**LAKE PONTCHARTRAIN, LA.
AND VICINITY
LAKE PONTCHARTRAIN
HIGH LEVEL PLAN**

**DESIGN MEMORANDUM NO. 19
GENERAL DESIGN**

**ORLEANS AVENUE
OUTFALL CANAL**

ENGINEERING CORRESPONDENCE LOG

FIGURE 15

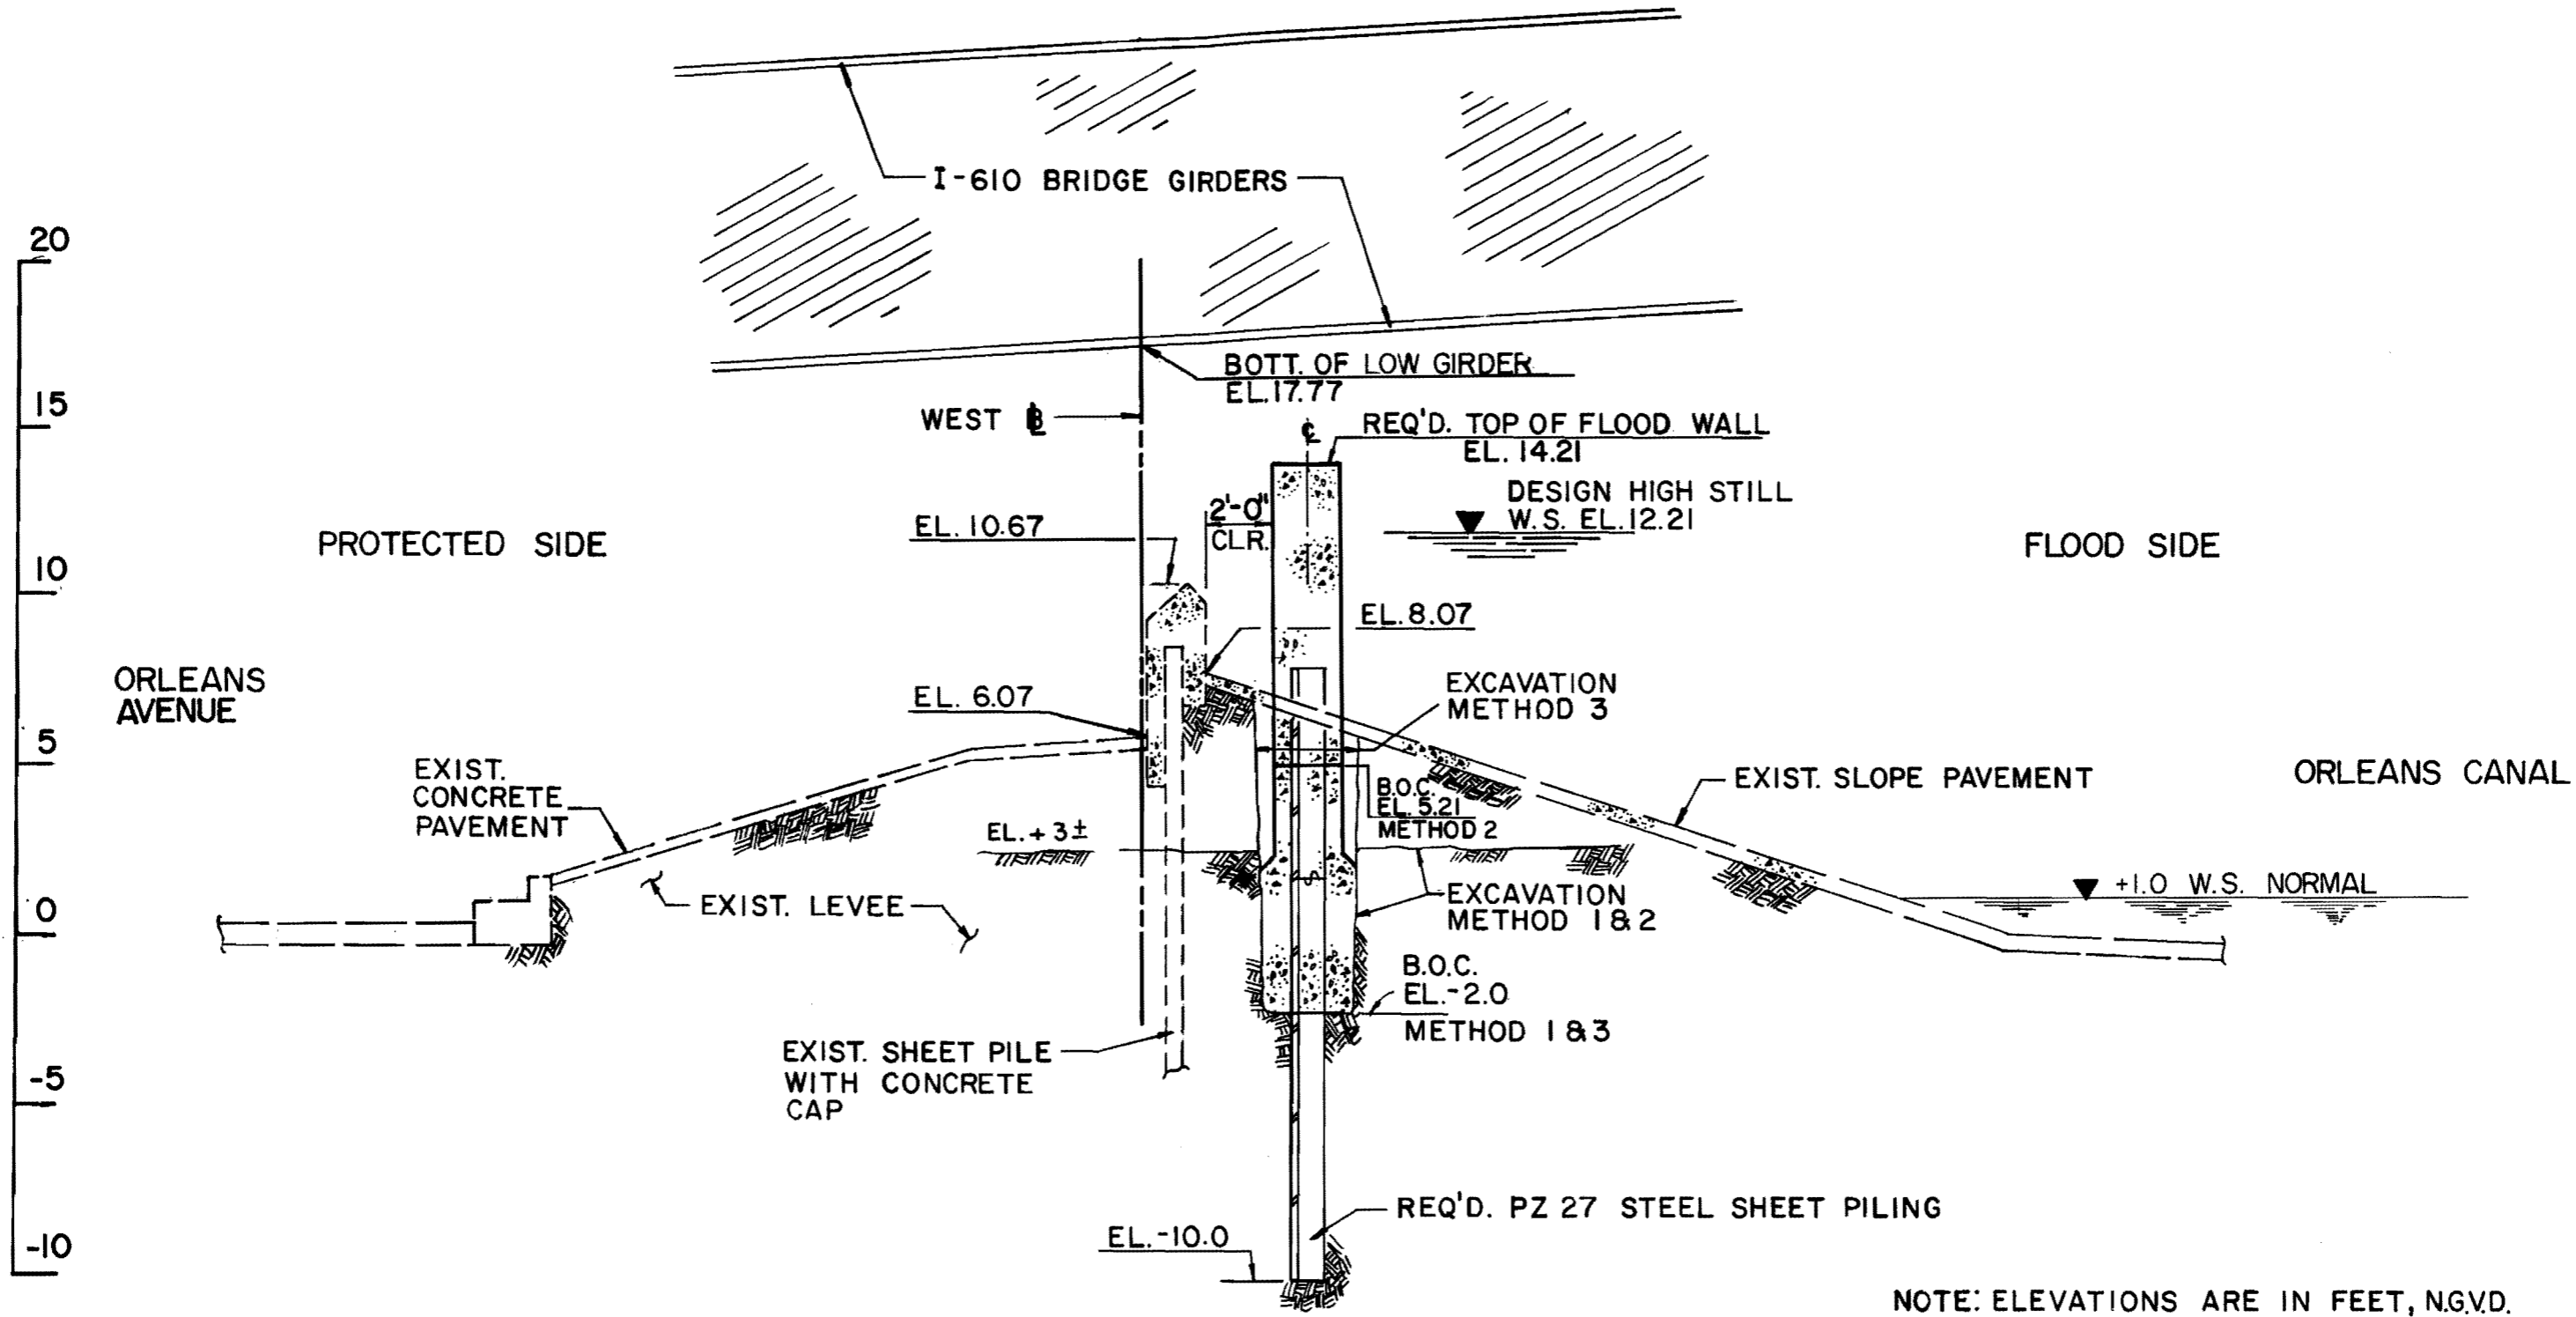
30. Reference chapter VII, paragraph VII A, and figure 15 - The draft geotechnical report for this project did not include any analysis for this reach and the I-wall at the I-610 bridge.

31. On figure 15, the bottom of the concrete cap for method 2 should be 2 feet below the ground surface as required by paragraph IV.D.1.

b. The sheet pile tip elevation for the I-610 bridge modification differs from that shown on Fig. 15. This discrepancy should be resolved.

Comment 30. The sheet pile tip elevation of -10 was shown in figure 15 and stated in chapter VII, paragraph VIIA of the GDM. A sheet pile tip elevation of -20 was used for Reach I west side of the canal while a tip elevation of -1 was used for the east side of the canal in the Draft Soils Engineering Report. Neither of these tip elevations agree with the tip elevation used in the GDM. We do not understand Eustis Engineering's response.

Comment No. 30 - The sheet pile tip elevation shown in figure 15 and stated in paragraph VIIA of the GDM (at I-610 Bridge) has been changed to agree with the tip elevations in the Soils Engineering Report. This change is also shown on the preliminary drawings for Phase II of the project submitted November 25, 1987.

| <b>FIGURE 16</b>                                                |                    |             |                       |                     |

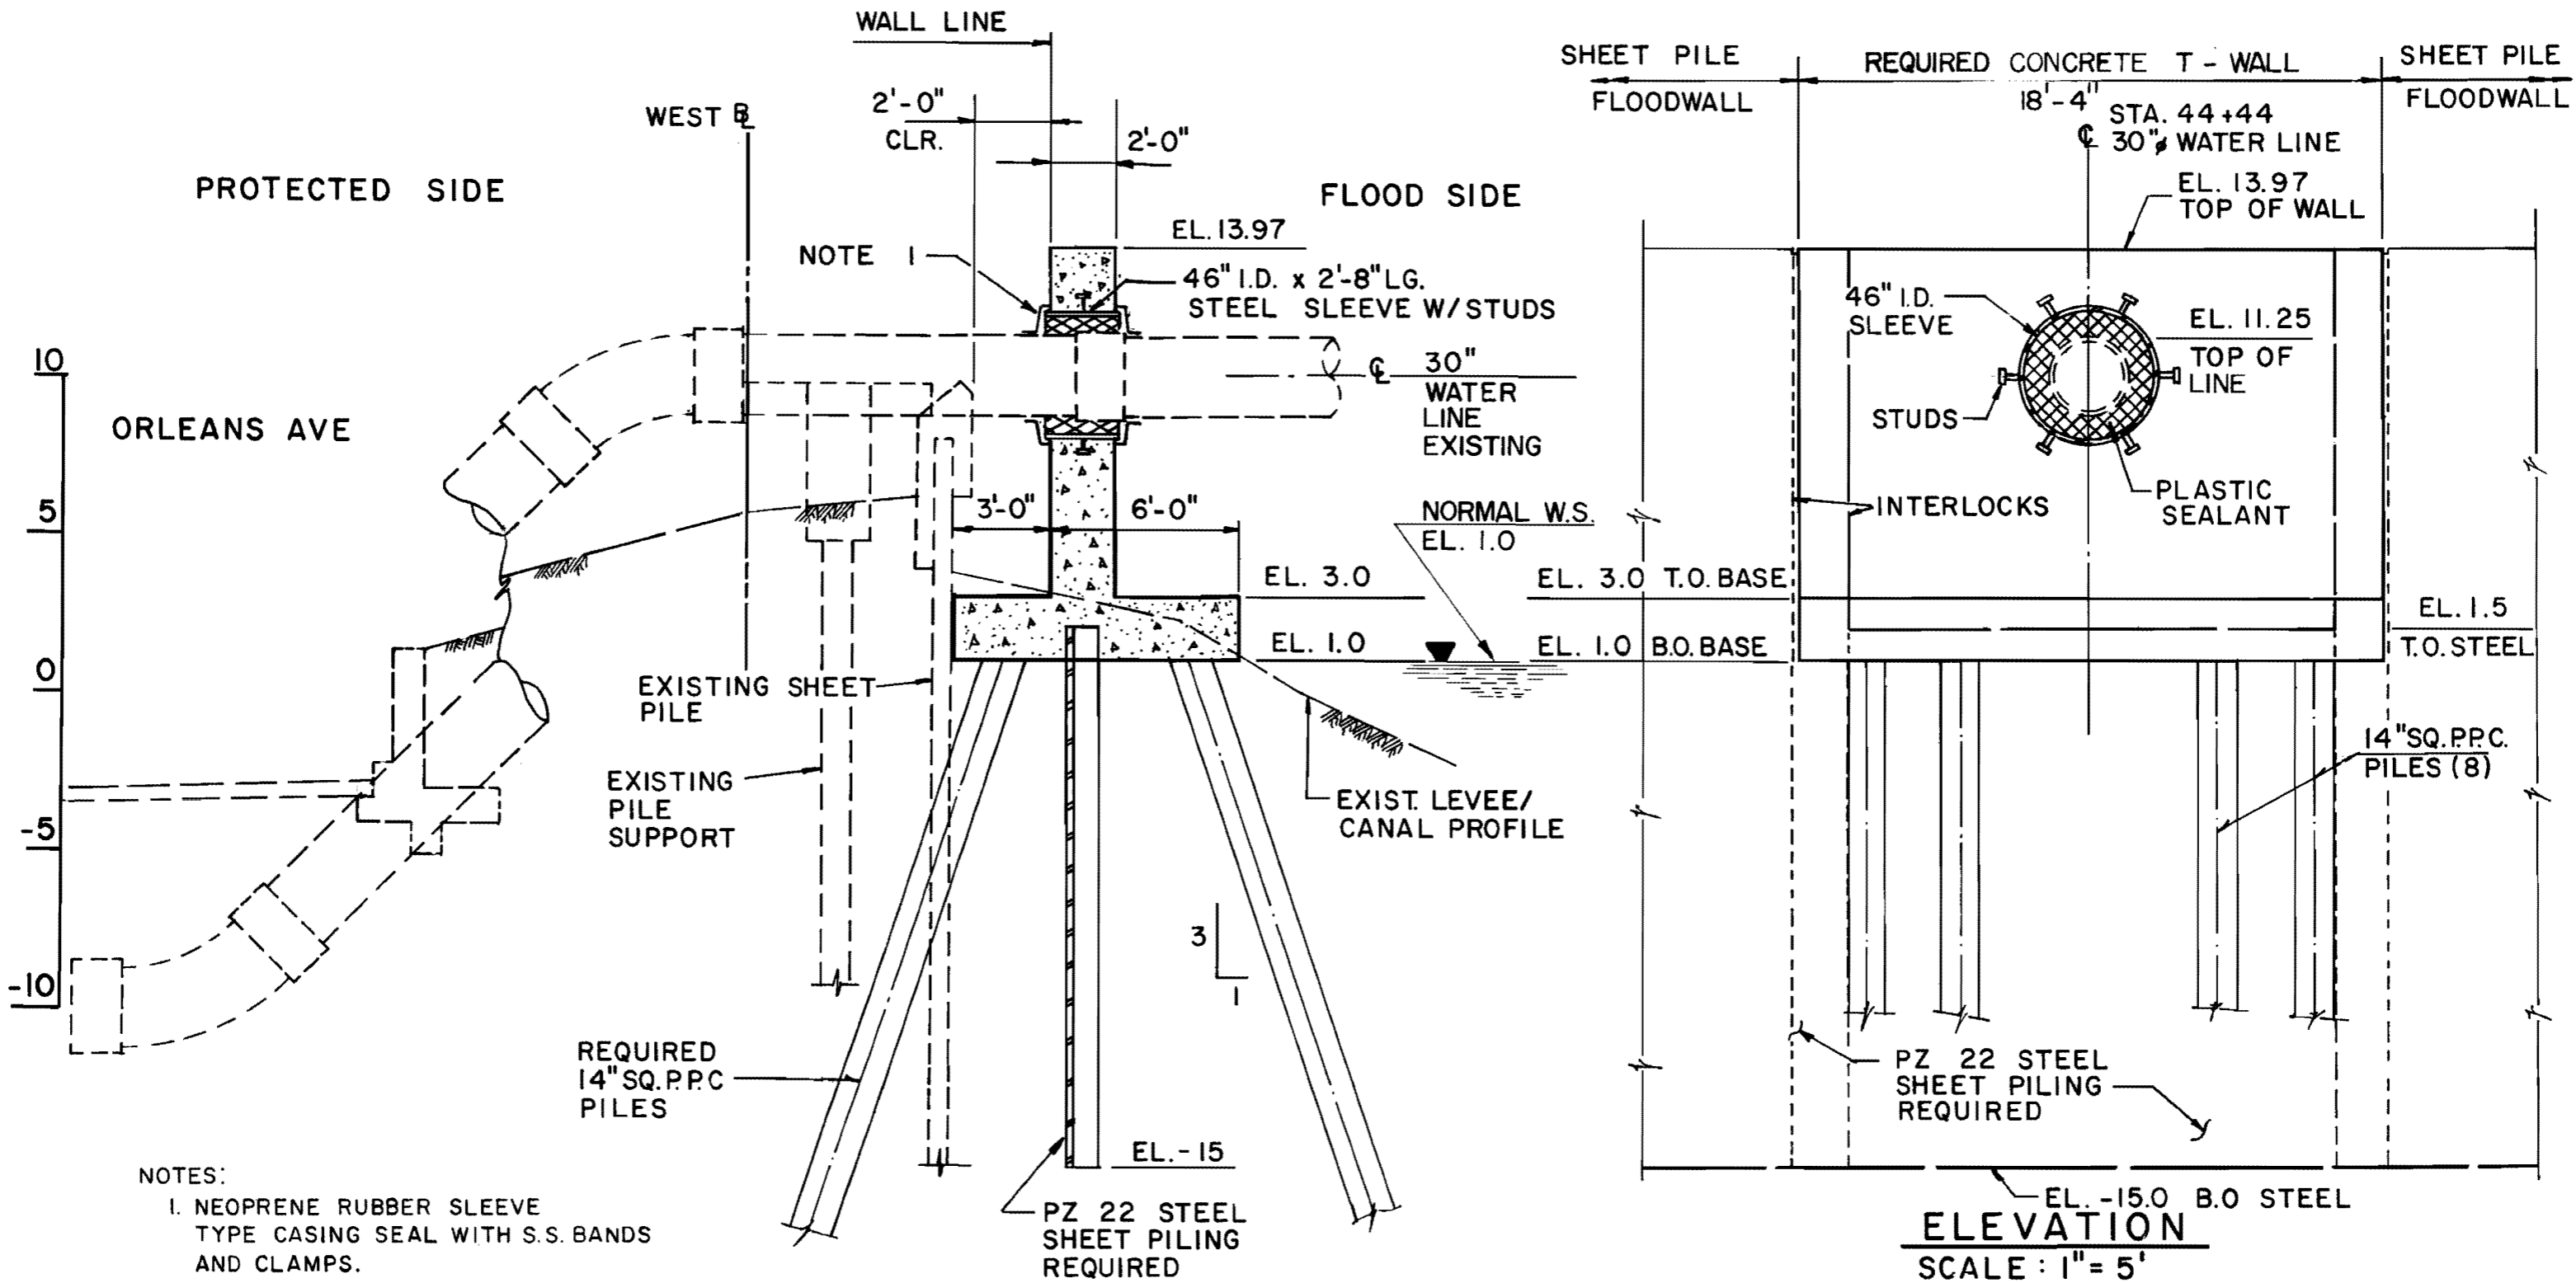
32. Reference figure 16-

**FIGURE 19**

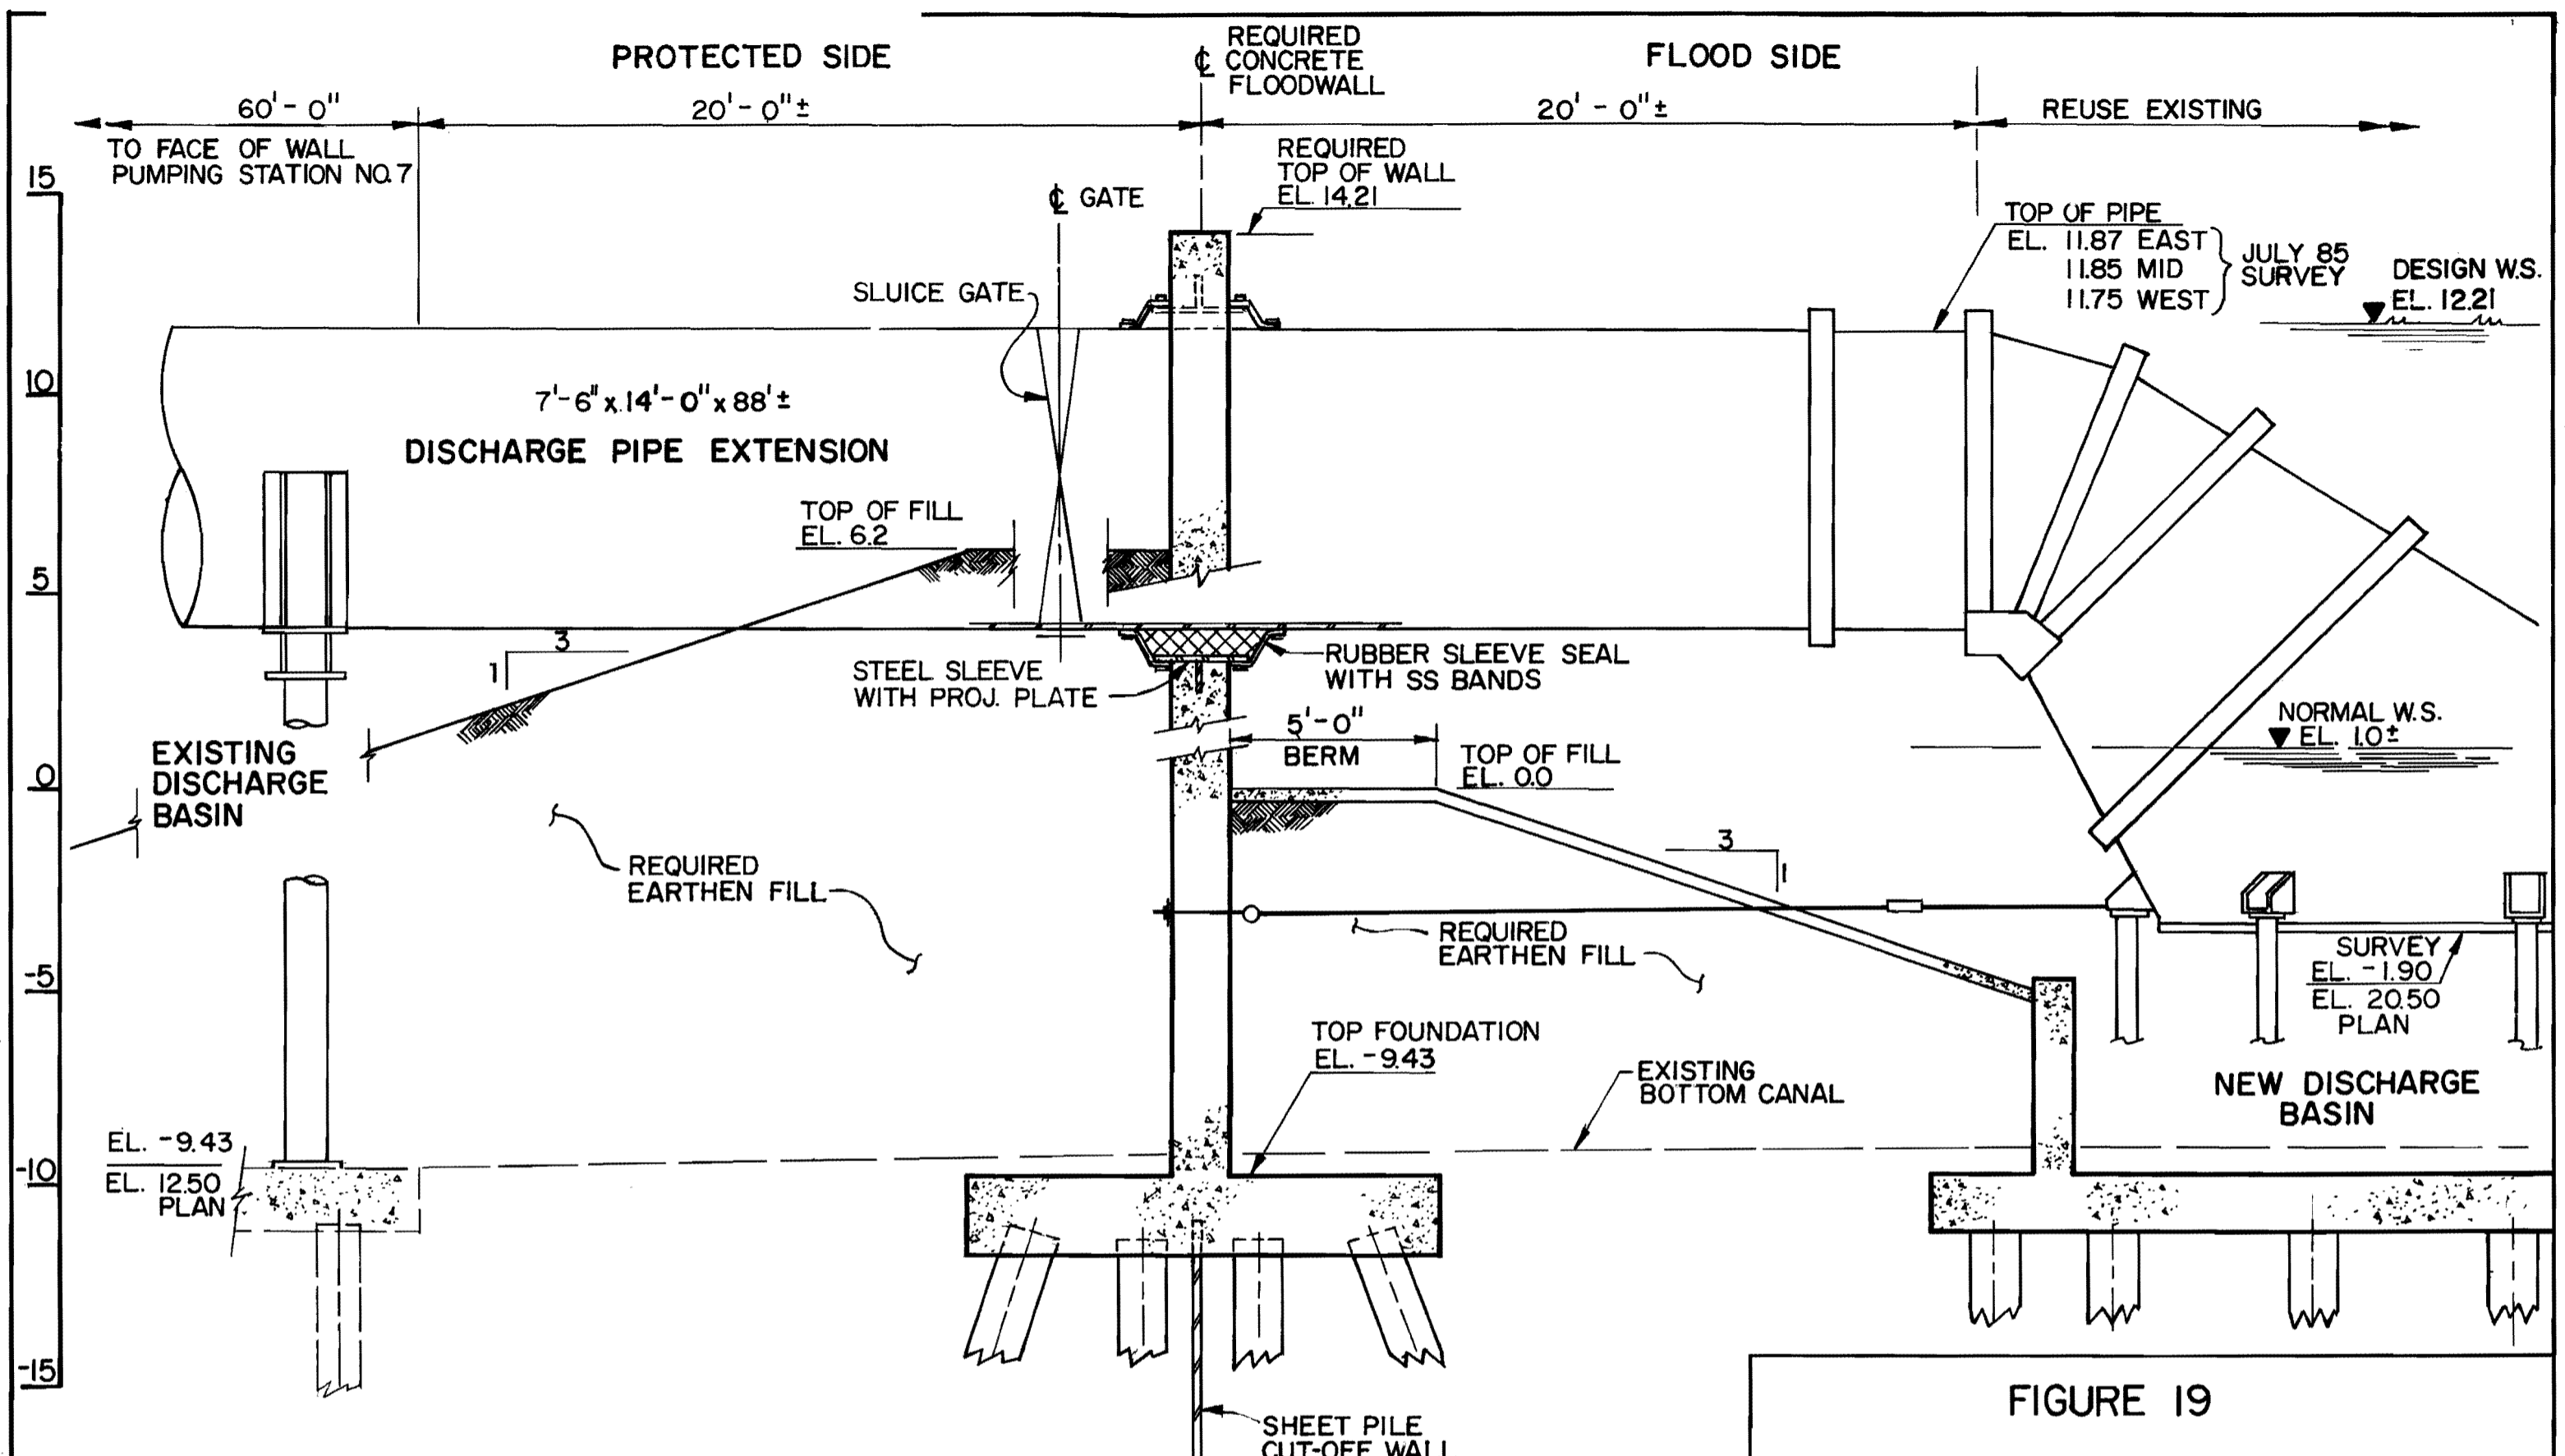
35. Reference figure 19 - Connecting of the discharge pipe to the proposed floodwall is unacceptable. Independent
